Our Ref: 19292

RE: PROPOSED CHANGE OF USE OF PART OF GOLF COURSE TO CEMETERY INCLUDING ALTERATIONS, ADDITIONS AND CHANGES TO/NEW ACCESS FROM PARK ROAD – 13-15 PARK ROAD, WALLACIA

We refer to the letter from Transport for New South Wales dated 27th March 2020.

KEY:

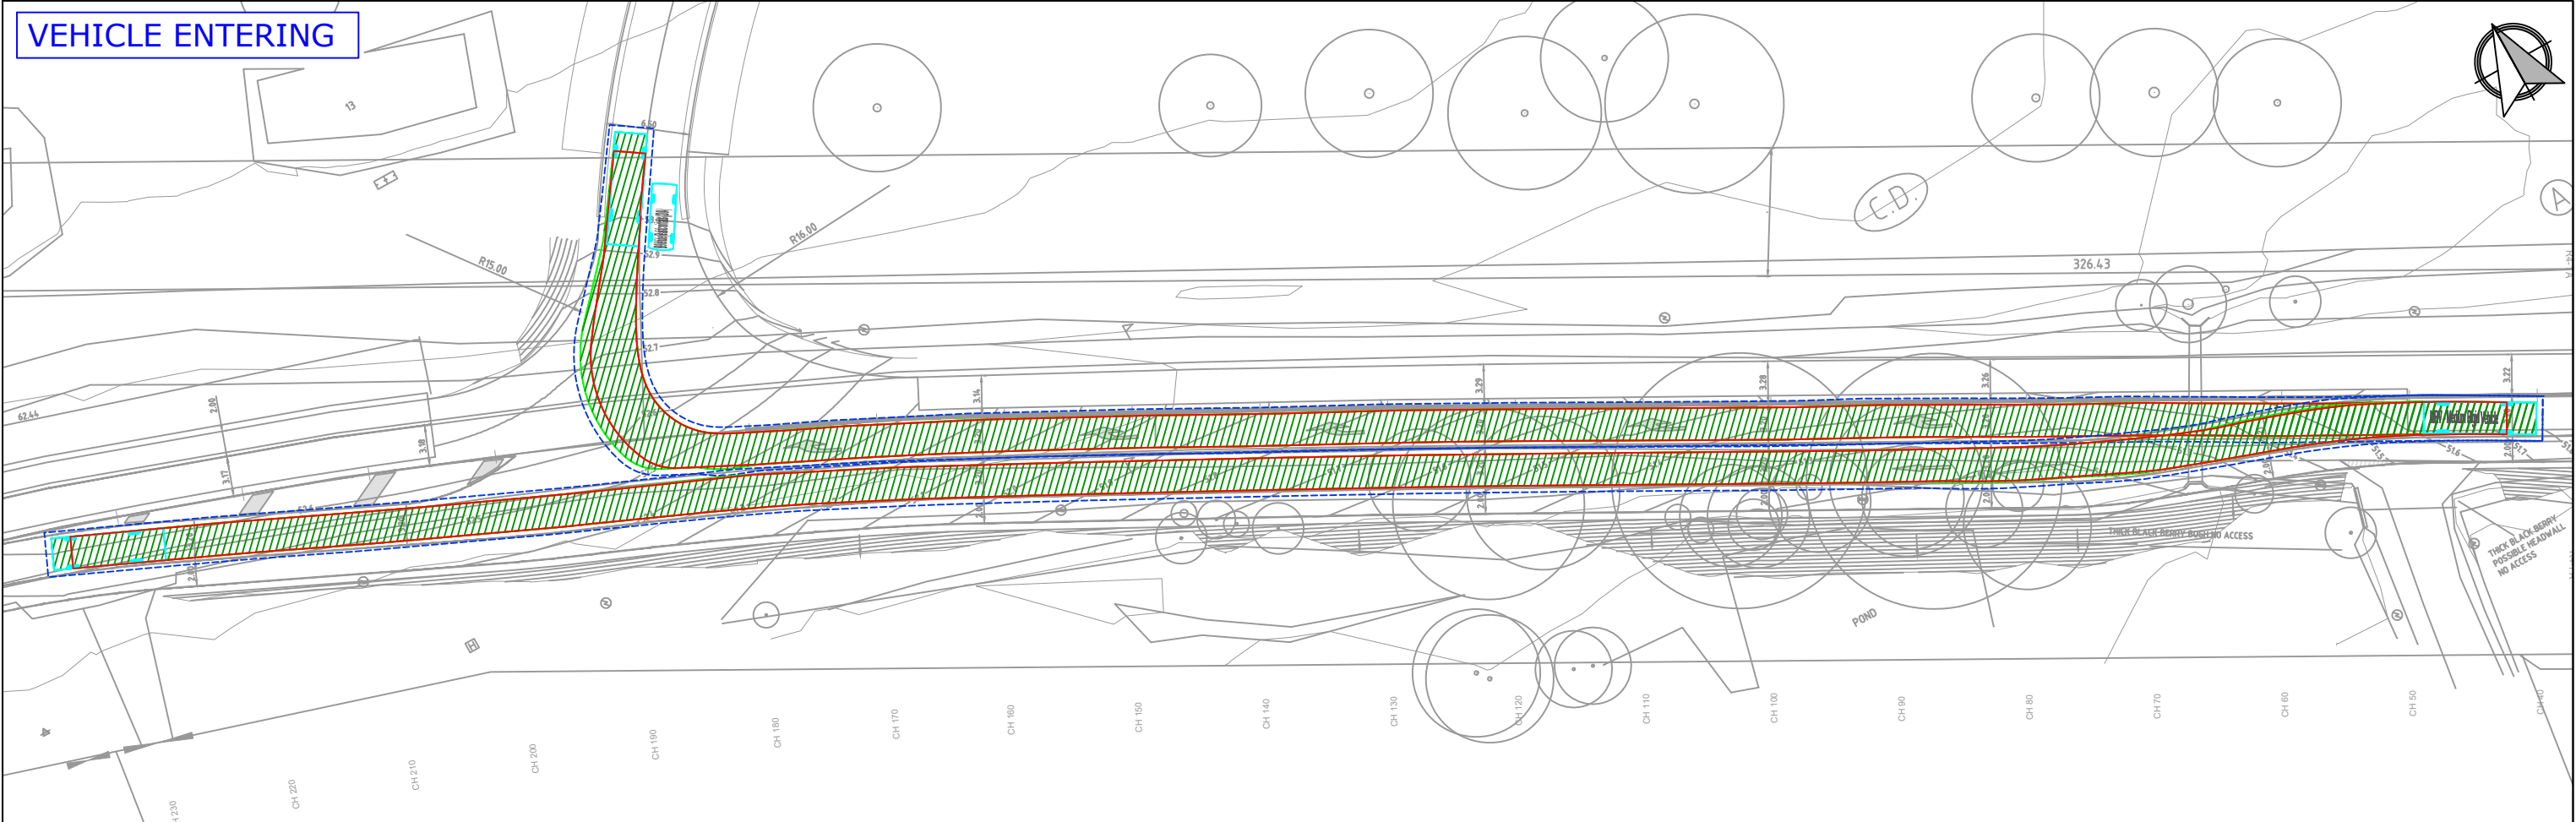
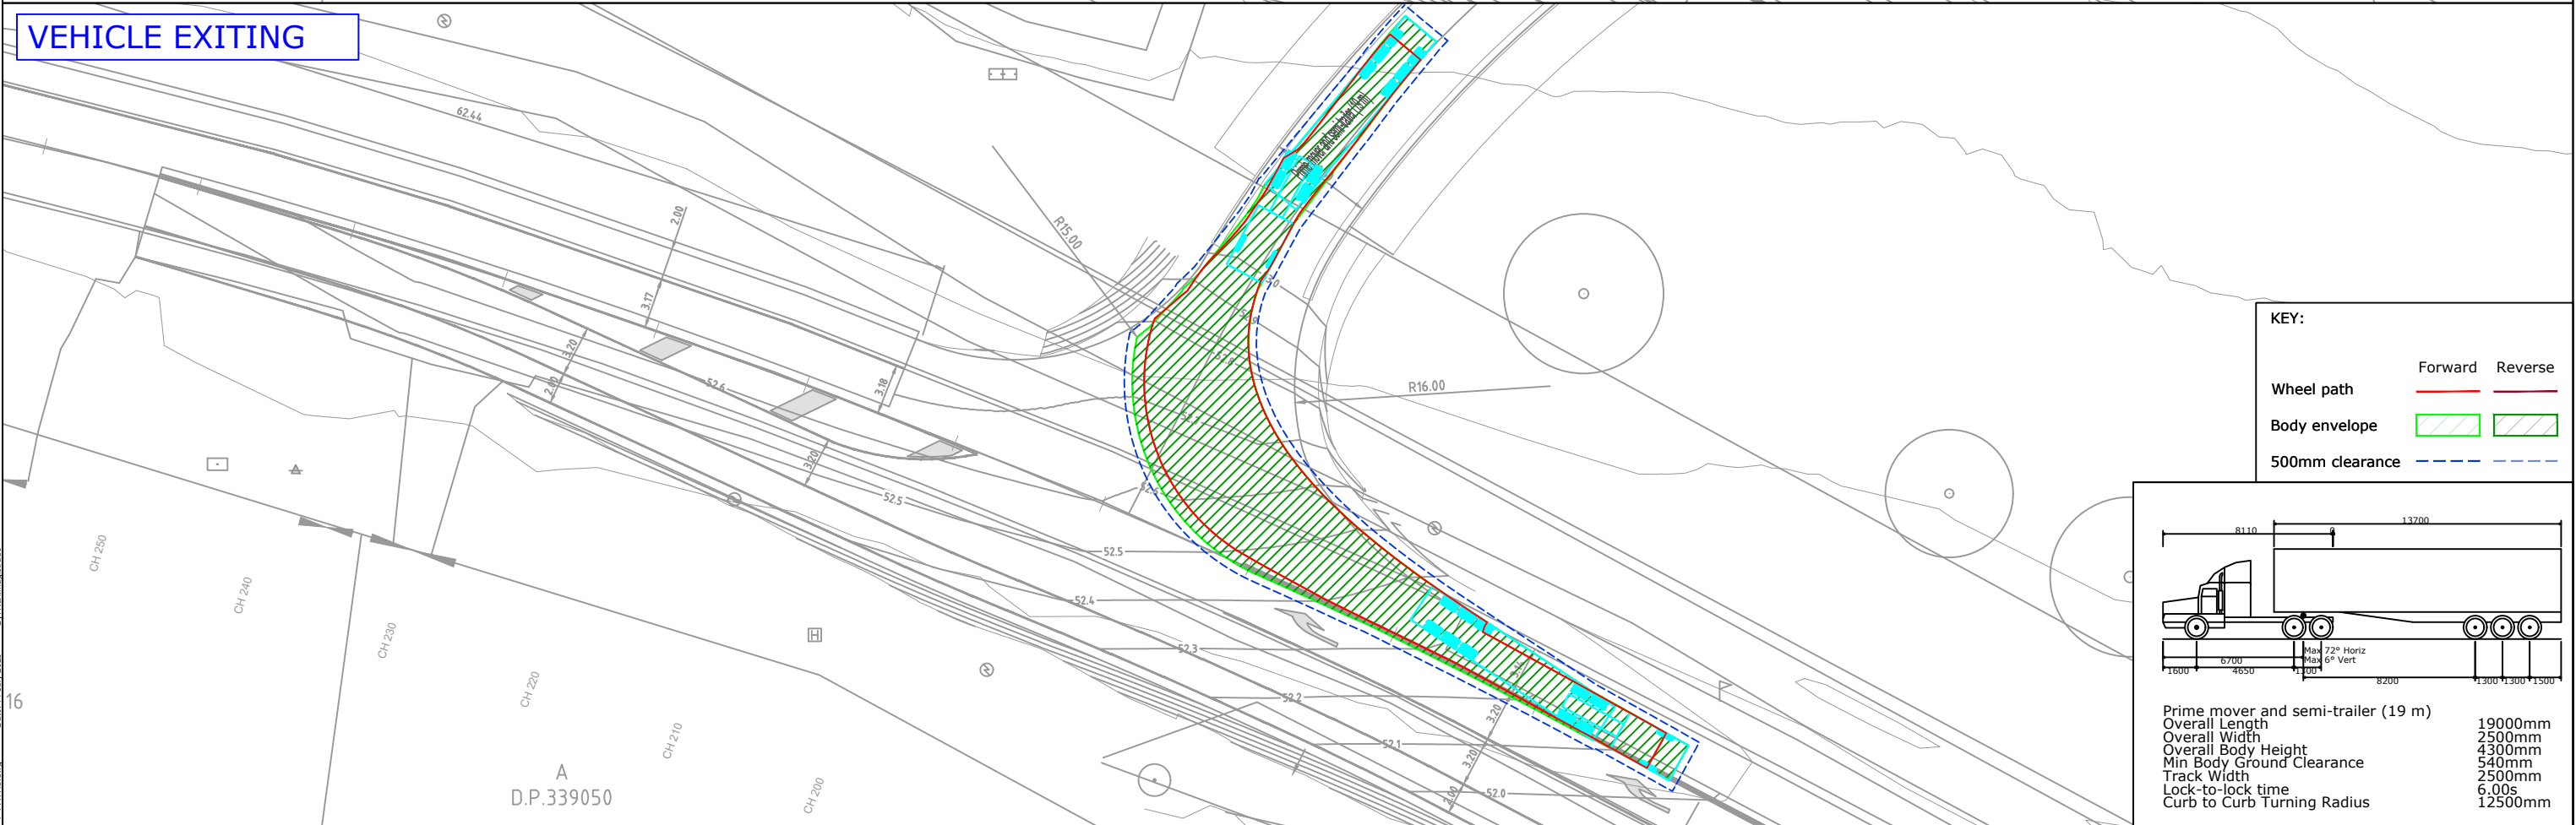
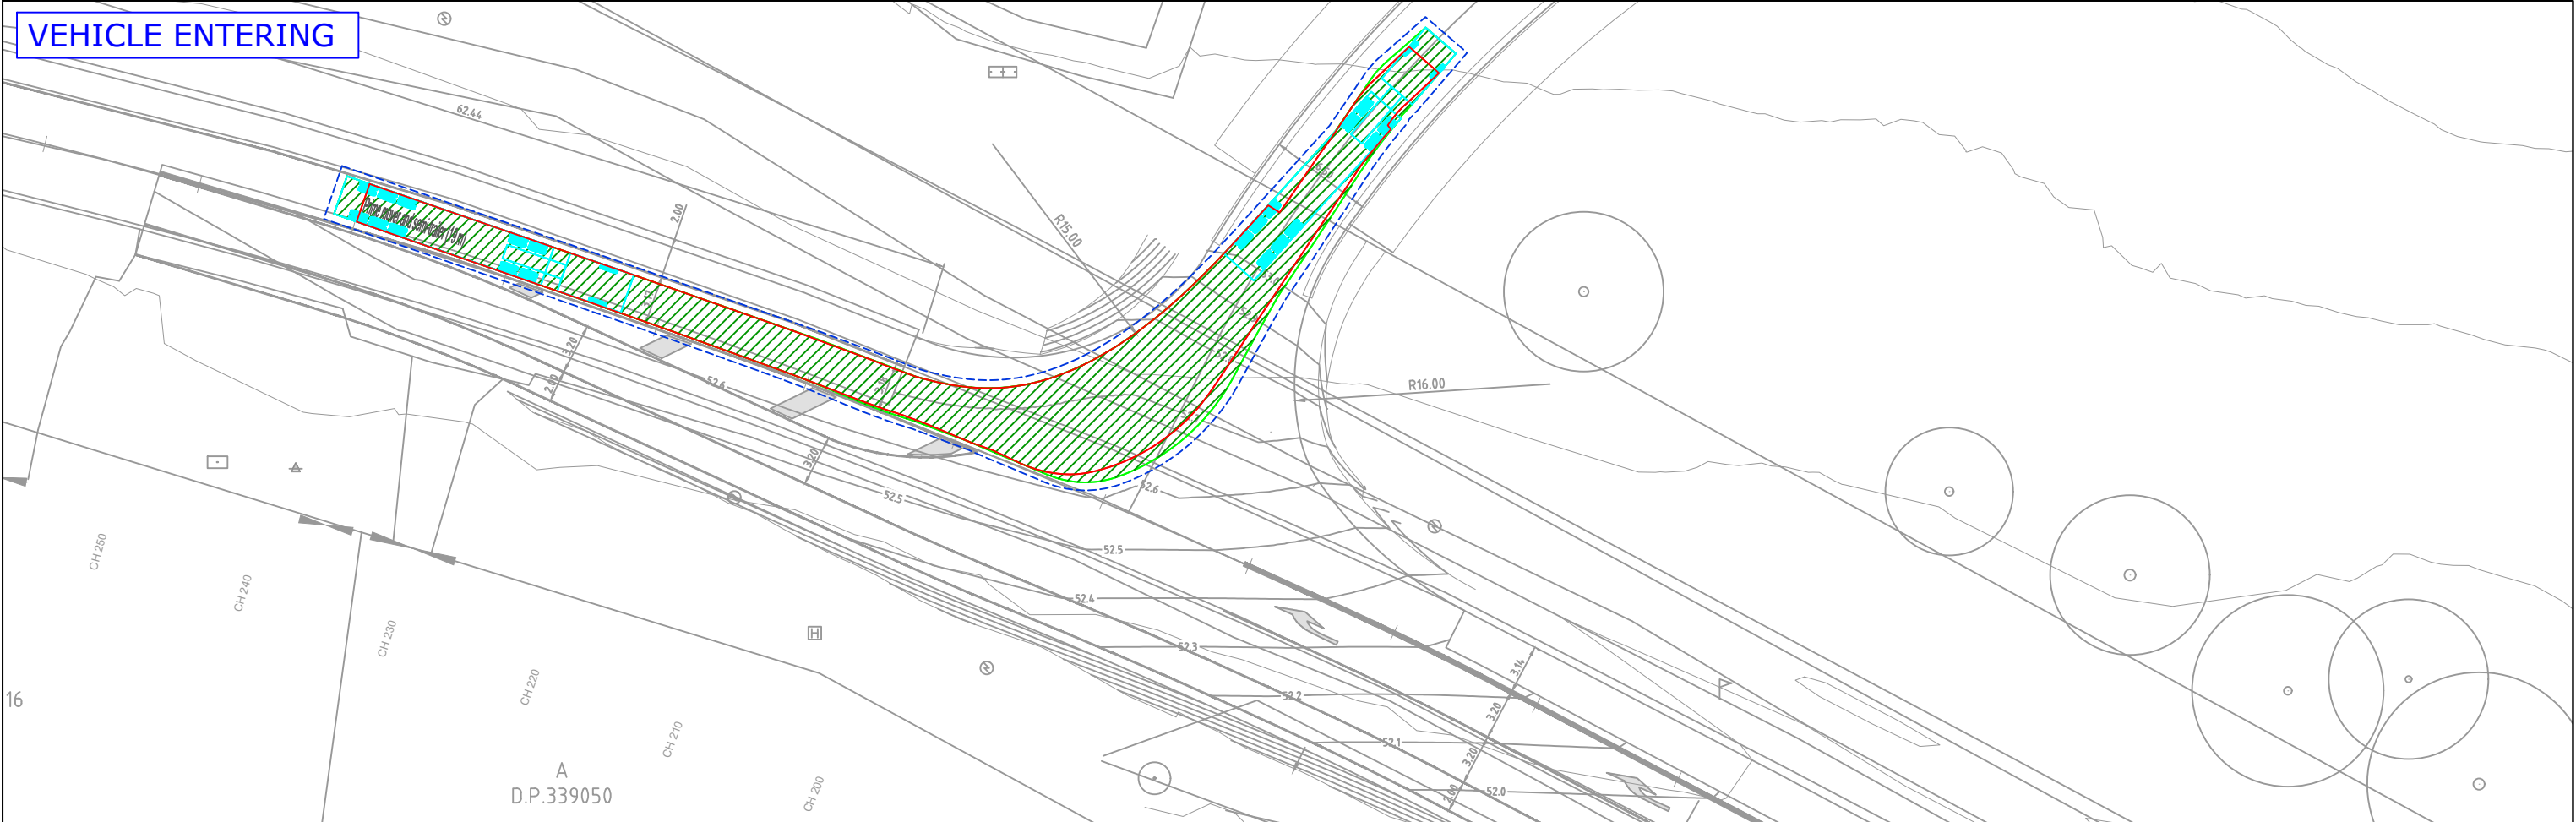
TfNSW now note that "the provided turn paths for an 8.8m vehicle provided are acceptable. Consideration should be given to larger vehicles (as a checking vehicle) for during construction it is likely 19m semi-trailers will be accessing the sites. In addition, the swept paths on Figure 9 depict a vehicle accessing/egressing the driveway from the wrong side of the road. Therefore, TfNSW requests updated swept paths to be provided which include a 19m checking vehicle and the swept paths in Figure 9 are to be flipped to the correct side of the road".

TTPP has undertaken swept paths on these new plans and there are contained at Appendix B.
